August 1, 1984

In the Matter of
LONG ISLAND LIGHTING COMPANY
(Shoreham Nuclear Power Station, Unit 1)
Docket No. 50-322-1 (OL)

Subject: Crankshaft Oil Hole Plug
P/N R-3149

R-3149

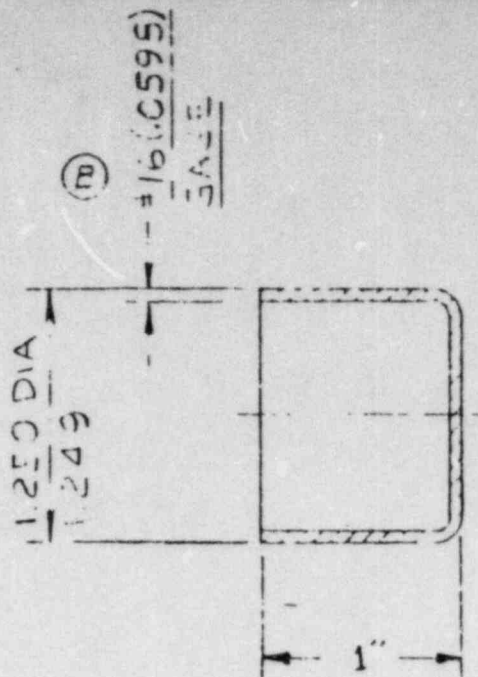
MATERIAL WAS 16 GAUGE (.0595) STEEL SHEET STAMPING.

REASON: EASE OF ASSEMBLY

.0259 OKF 7/6/84
 MATERIAL WAS 22 GA. (~~.0229~~) COLD ROLLED STL.
 REASON: TO LESSEN CHANCE OF DAMAGE TO PLUG AT INSTALLATION
 REMARKS: NEXT PART MADE MUST BE PER THIS REVISION
 MISC. 82-135

B 6-15-82 MATL WAS 226A
10299 JTL SH

R-3149

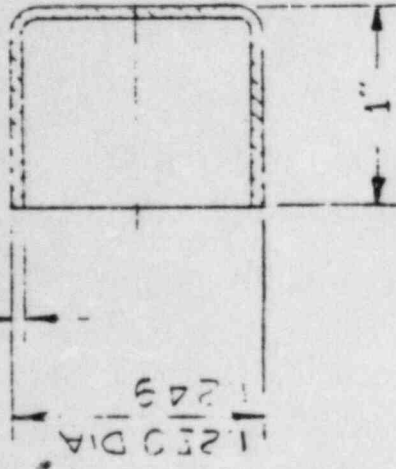
MATERIAL WAS 16 GAUGE (.0595) STEEL SHEET STAMPING.

REASON: EASE OF ASSEMBLY

MATERIAL WAS 22 GA. (~~229~~) COLD ROLLED STL.

REASON: TO LESSEN CHANCE OF DAMAGE TO PLUG AT INSTALLATION

B 6-5-92
A 2-27-92
MATERIAL WAS 2024-T3 ALUMINUM

R-3149

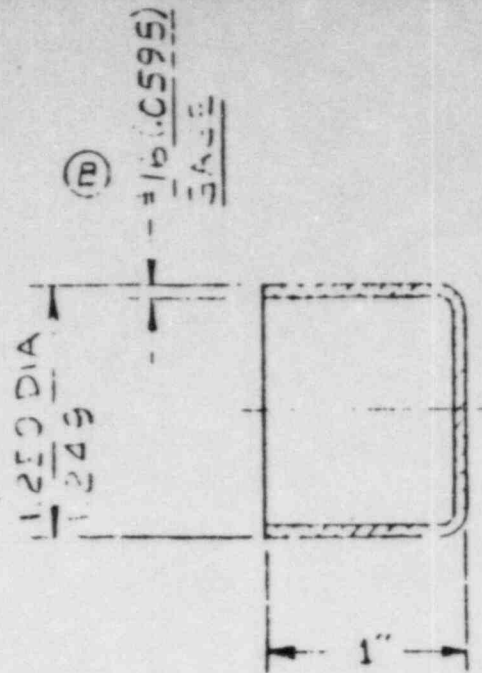
MATERIAL WAS 16 GAUGE (.0595) STEEL SHEET STAMPING.

REASON: EASE OF ASSEMBLY

10299 OK F 7/6/84
 MATERIAL WAS 22 GA. (~~.0229~~) COLD ROLLED STL.
 REASON: TO LESSEN CHANCE OF DAMAGE TO PLUG AT INSTALLATION
 REMARKS: NEXT PART MADE MUST BE PER THIS REVISION
 MISC. 82-135

B 6-15-32 MATL WAS 22GA
0299 JTL SMT

R-3149

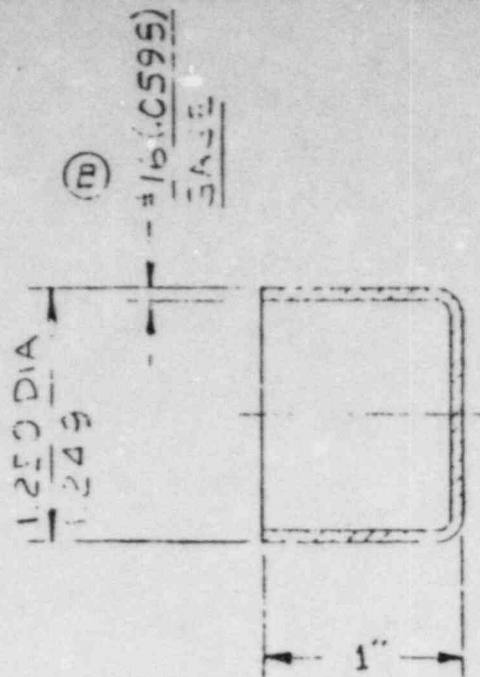
B 6-5-82 MAPL WAS 22GA
0299 JTL SHT

A 2275 JTL SHT
